UNITED STATES ENVIRONMENTAL PROTECTION AGENCY  
WASHINGTON, D.C. 20460

December 19, 2014

In response to stakeholder comments received on the ENERGY STAR Version 6.0 Draft 2 Residential Dishwasher Specification, and new data supplied by the U.S. Department of Energy (DOE), the U.S. Environmental Protection Agency (EPA) is releasing for comment a supplemental proposal specific to the optional criteria for connected functionality. Note that this supplemental proposal is limited to the demand response criteria included in Section 5G of the Draft 2 specification.

**Unit 2: Multiple Heated Fills, Power Dry, Mid Pump Power**

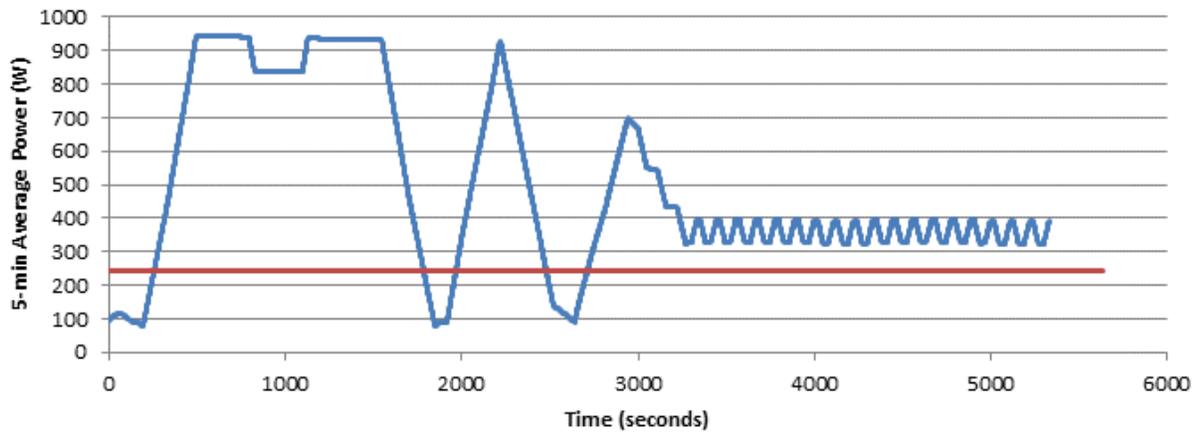
Accordingly, EPA is proposing that dishwashers restrict average power draw over TALR load reduction periods to no more than 250 watts. This level is informed by DOE dishwasher test data, included herein, and will provide load shed comparable to the prior 50% reduction criterion. Under this criterion, a dishwasher may need to suspend water heating and power dry, but could continue other operations, including circulating water, soil sensing, and soil sensor calibration. In support of this proposal, plots showing the DOE dishwasher test data are

included that show the full-cycle power draw as a function of time for several ENERGY STAR certified dishwashers, with and without power dry. Since the 250 watt level will allow soil sensing and sensor calibration to take place during TALR response periods, EPA is proposing to remove the Draft 2 Section 5.G.2.c criterion, which allowed up to a 60-second TALR delay to facilitate completion of soil sensing and soil sensor calibration.

*Temporary Appliance Load Reduction Capability: The capability of the product to respond to a signal by providing load reduction for a short time period, typically 10 minutes. Upon receipt of signal and in accordance with consumer settings, except as permitted below, the product shall restrict its average power draw during the load reduction period to no more than 250 watts. (deleted Draft 2 text: 50% relative to the baseline average power draw defined in the Test Method to Validate Demand Response)*
